FLYING HORSE NORTH FILING NO. 4
CONSTRUCTION DOCUMENTS
A TRACT OF LAND BEING A PORTION OF SECTION 30, TOWNSHIP 11 SOUTH,
RANGE 65 WEST OF THE 6TH P.M., AND A PORTION OF SECTION 31, TOWNSHIP 11
SOUTH, RANGE 65 WEST OF THE 6TH P.M.,
CITY OF COLORADO SPRINGS, COUNTY OF EL PASO, STATE OF COLORADO

AS-BUILT VERSION 1.0, DATED 7/22/2026
PE: RICHARD LYON
CO PE NO. 53921

FLYING HORSE NORTH FILING 4
PRI #2, LLC.
EL PASO COUNTY, CO

CULVERT 15
PUB. STORM CULVERT PIPE WITHIN OLD STAGE COACH
PUB. 80' ROW - COLLECTOR

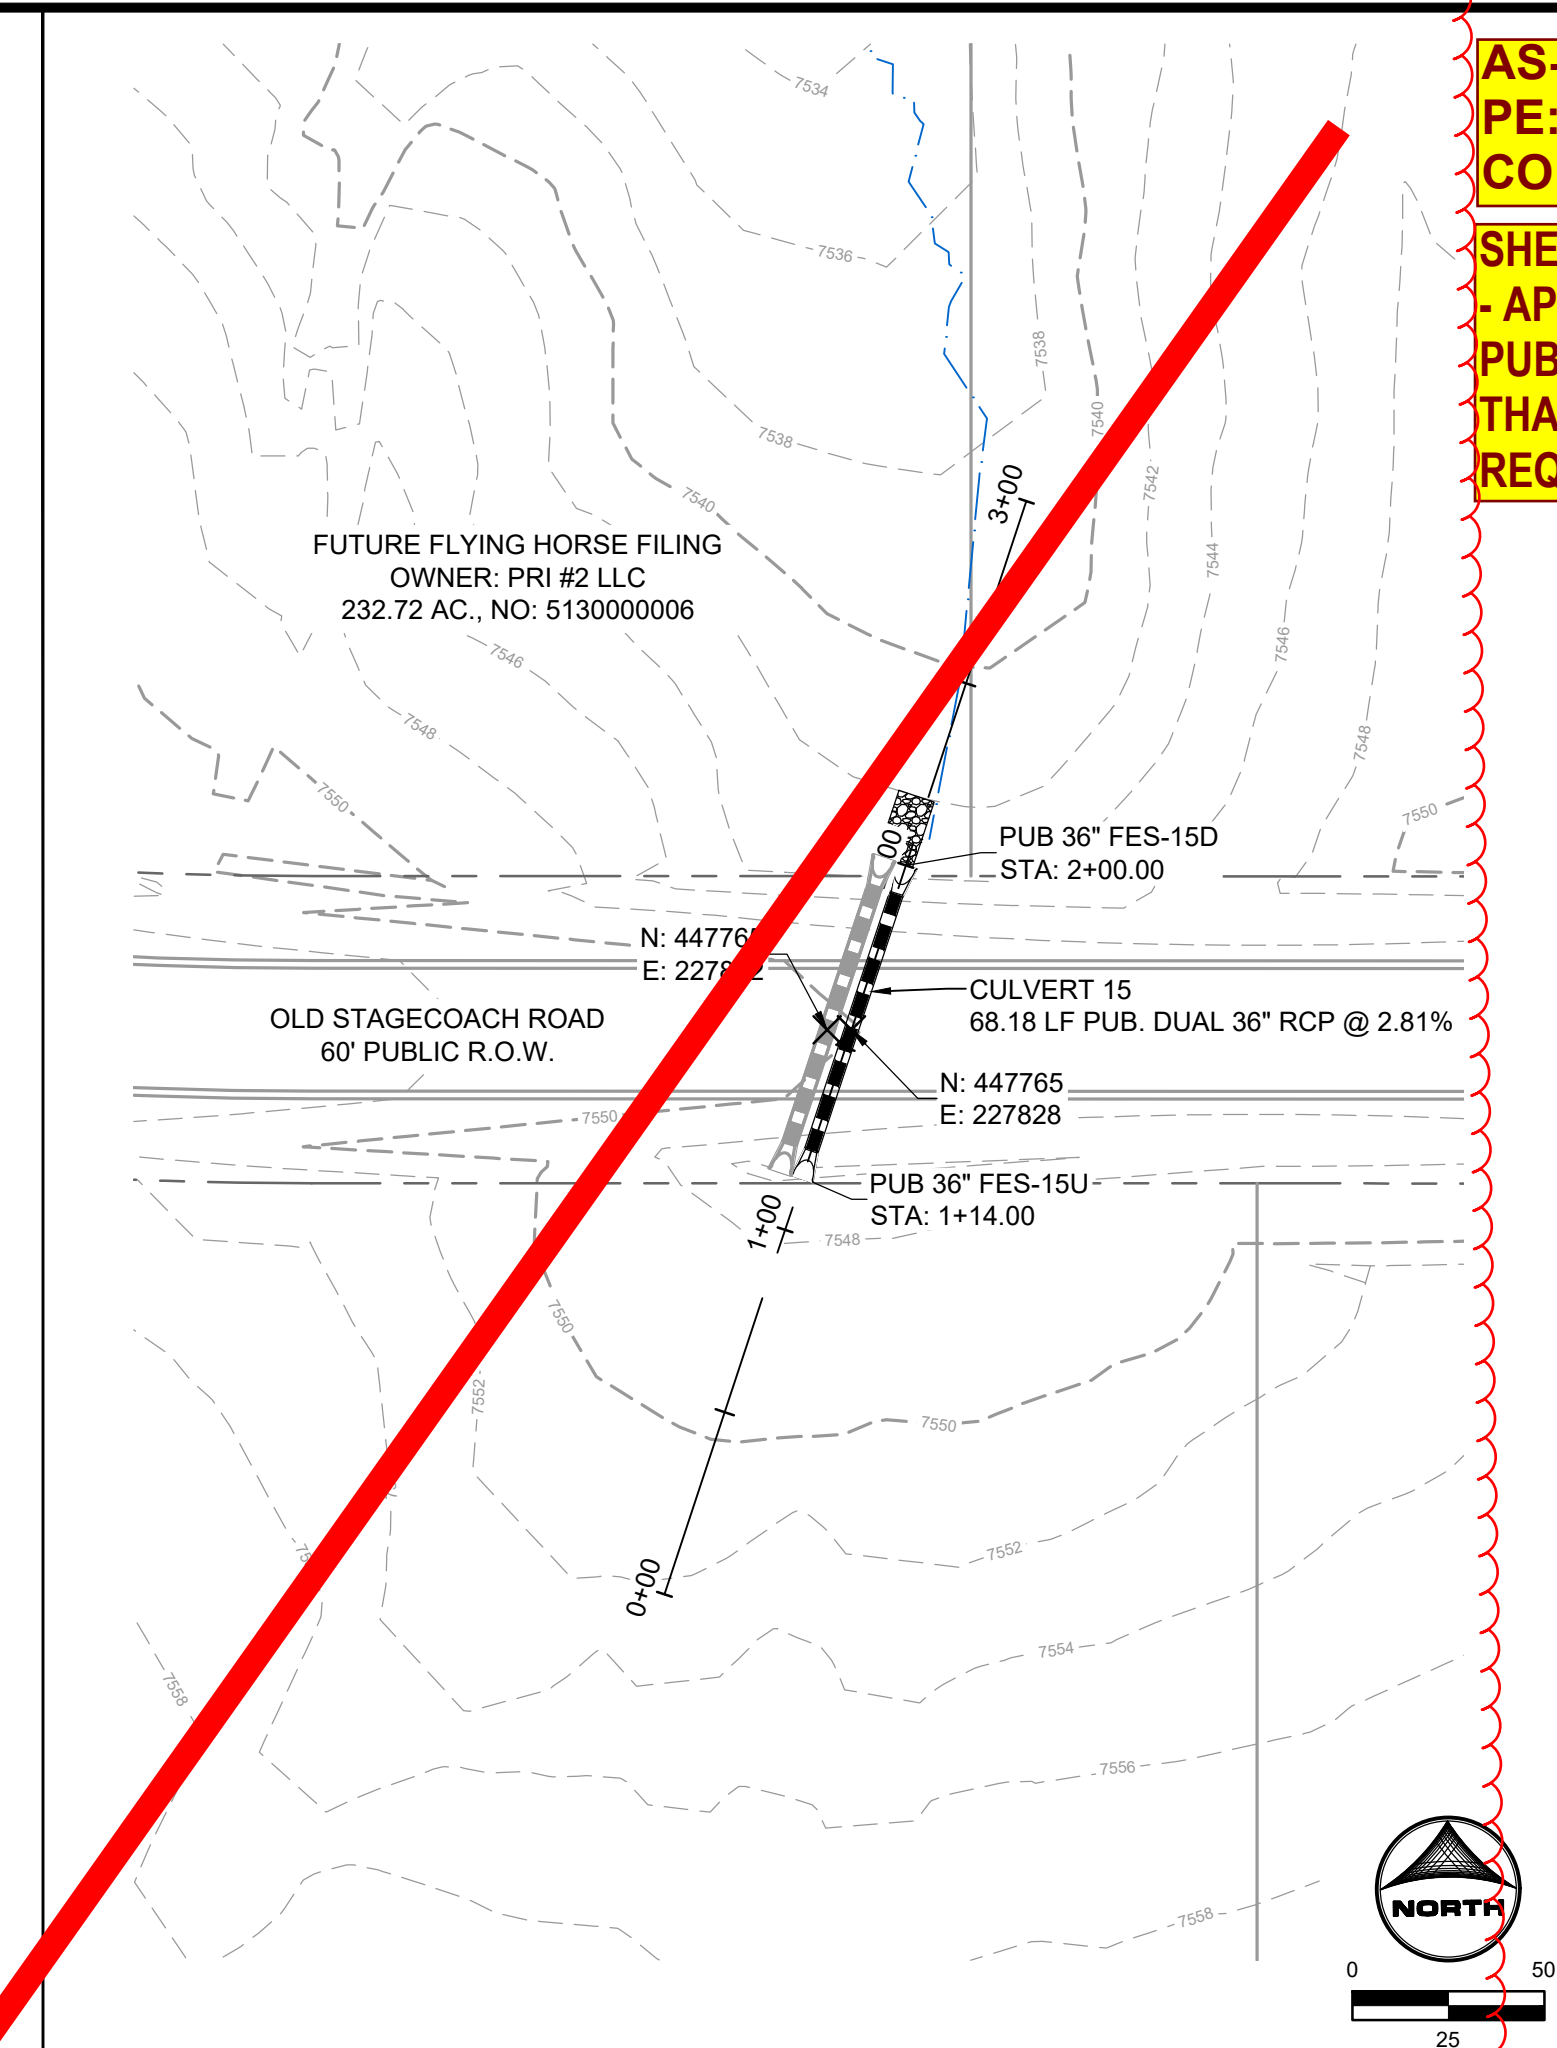
SHEET 18:
- APRIL 2025: DISCUSSIONS WITH EPC
PUBLIC WORKS STAFF, DETERMINATION
THAT CULVERTS 14 AND 15 WERE NOT
REQUIRED TO BE INSTALLED.

POND DETAILS
POND A FOREBAY

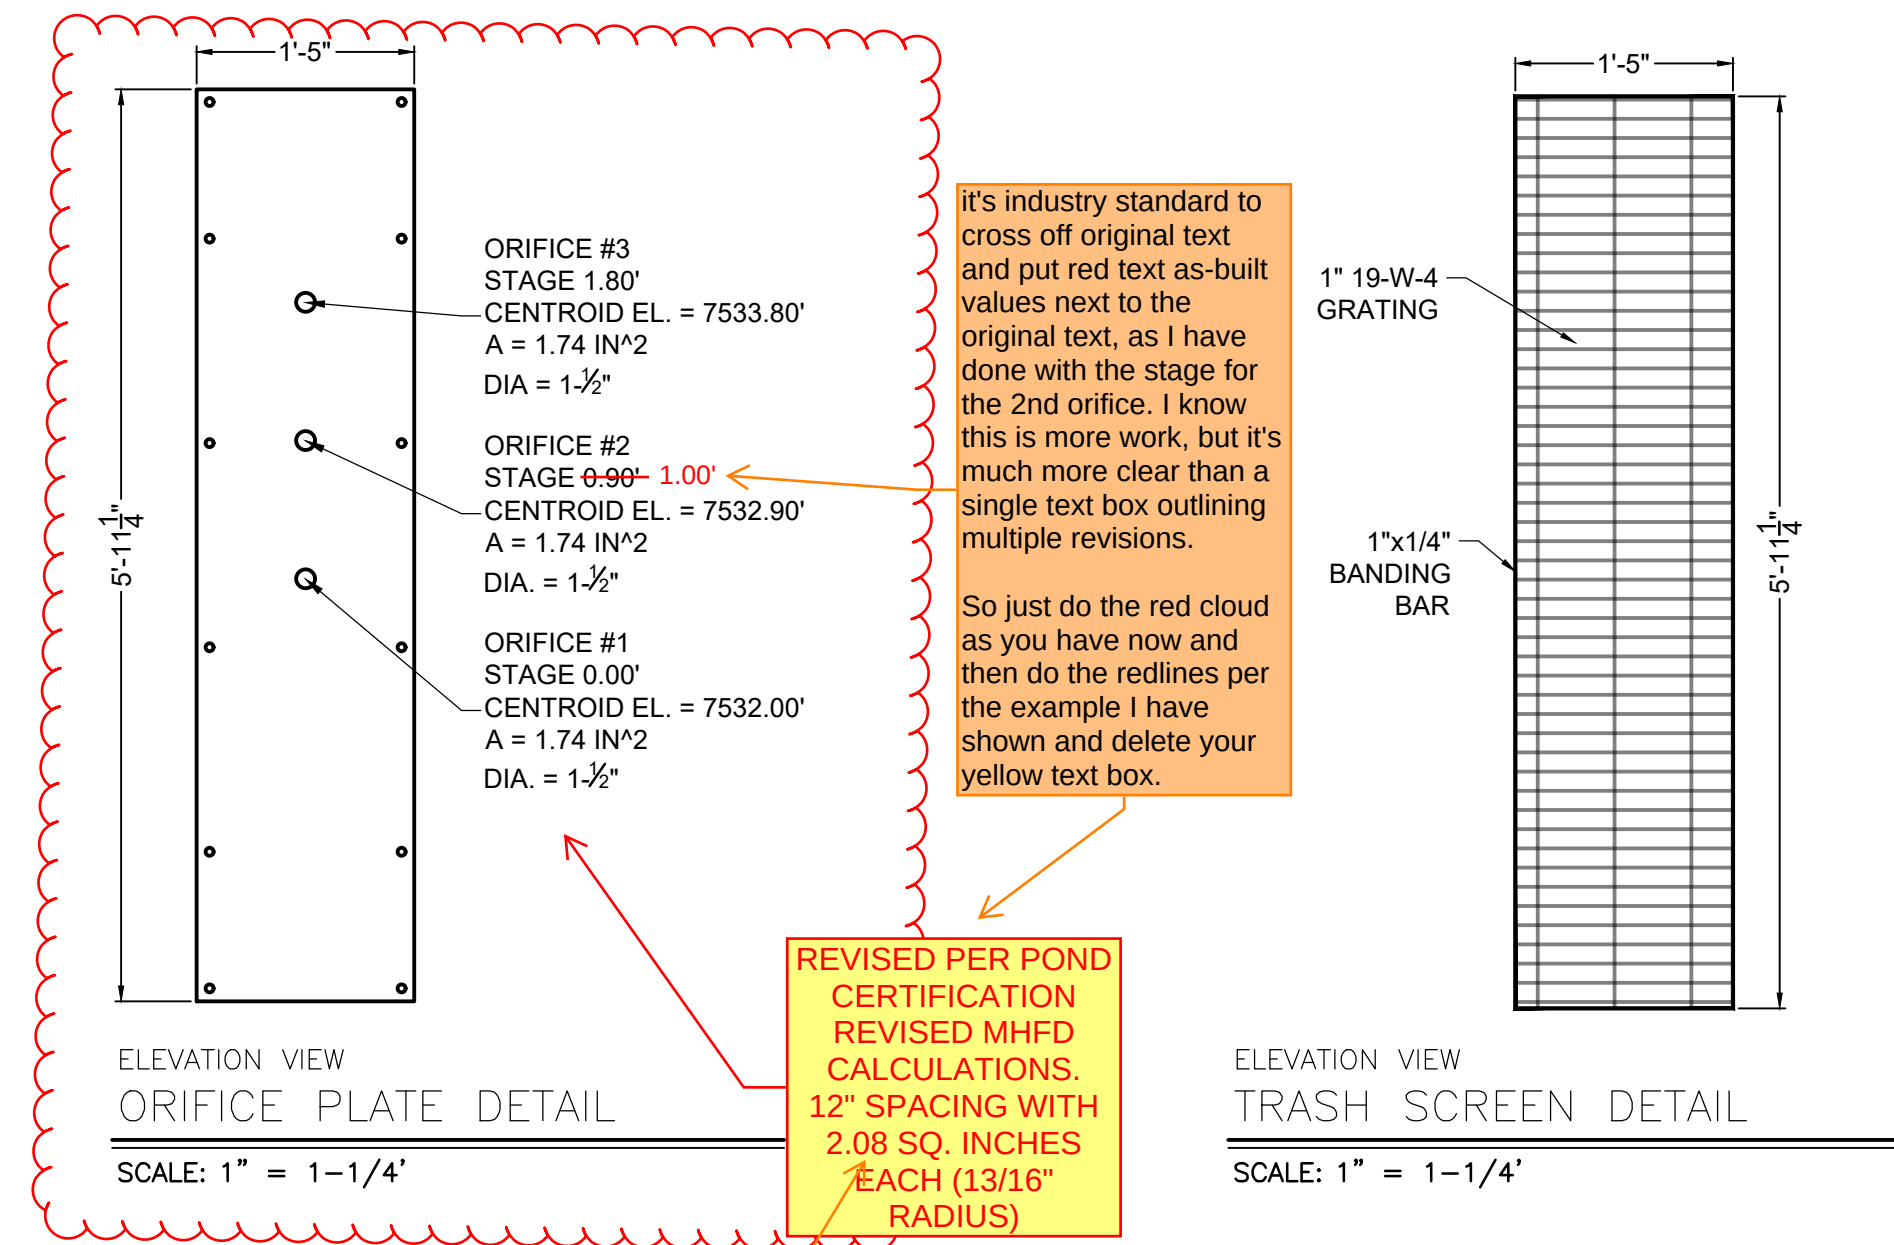
This was revised in the as-built calcs so subsequently should be redlined on the CDs here too.

This is another good example of a redline that is not appropriate for as-builts. In 5yrs when someone looks at this, it will be very confusing to see that the steps were installed in the field, but there's no redline confirming that the adjacent trash screen (for example) was installed in the field. And people will be wondering what the implication of that is.

it's industry standard to cross off original text and put red text as-built values next to the original text, as I have done with the stage for the 2nd orifice. I know this is more work, but it's much more clear than a single text box outlining multiple revisions. So just do the red cloud as you have now and then do the redlines per the example I have shown and delete your yellow text box.

calcs show 2.11 sq in, so revise one/both to remove discrepancy. And change dimension to diameter (not radius) to match original design detail above.

REVISED PER POND CERTIFICATION REVISED MHFD CALCULATIONS. 12" SPACING WITH 2.08 SQ. INCHES EACH (13/16" RADIUS)
